One of the many ways DPR determines the amount of risk involved in a project is through the review of the design documents. If the design documents are difficult to interpret or incomplete the project will be difficult to build, exposing DPR to more risk and unforeseen costs.

Because of the complexity of GATTACA's equipment it is essential that the proper utilities are routed to each piece of equipment. Your task will be to review the equipment list provided and confirm all utilities have been identified accordingly on the design documents.

MEP Equipment Constructability Review		
Equip #	Equipment Name	Comments
600	1/2 L Fermentor (bank of six)	Ducted exhaust only shown on architectural and DI water is required per the equipment list but is not shown on the plumbing sheets.

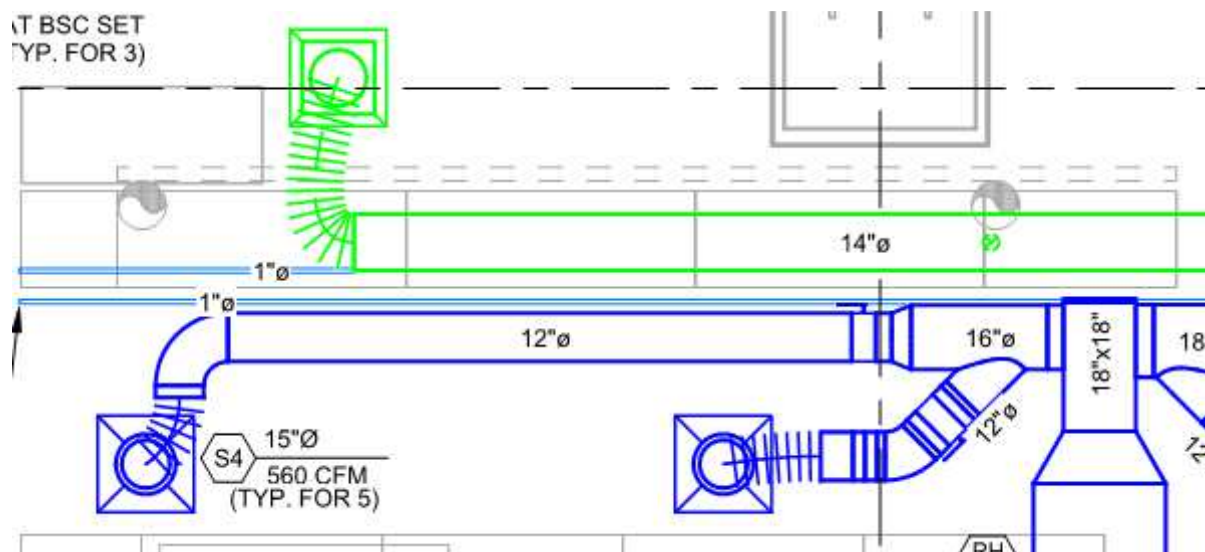
- b. **Architectural:** The 4" Ducted exhaust is shown on the architectural plans. ✓

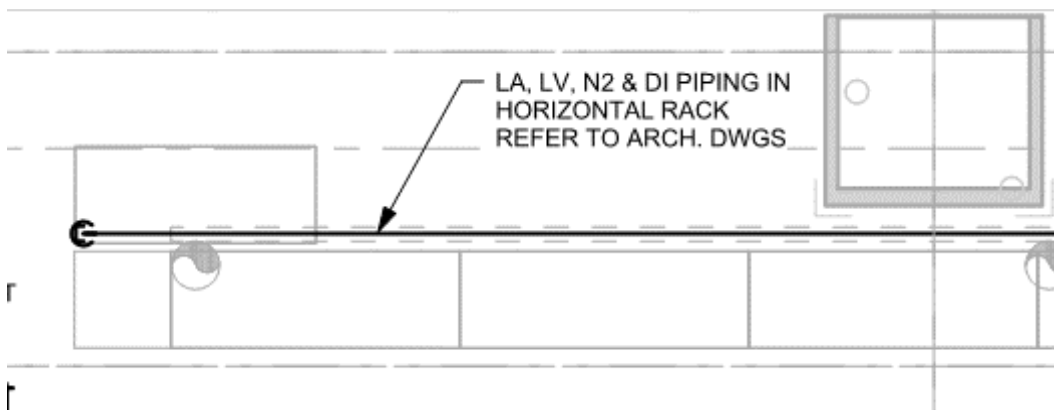
- c. **Mechanical:** No ducted exhaust is shown on the mechanical plans. We should make a note of this.

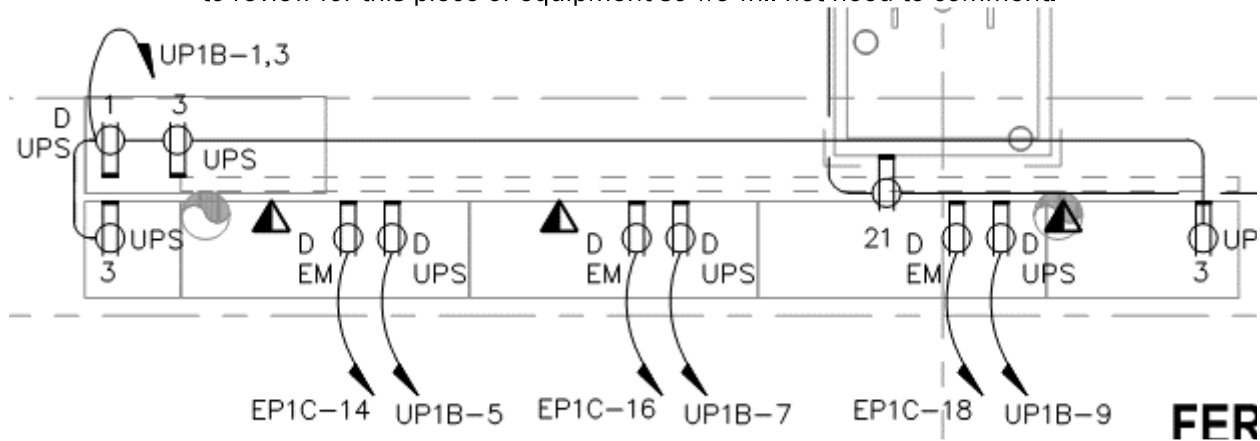
- d. **Plumbing:** All required plumbing is shown on the plumbing plans. ✓
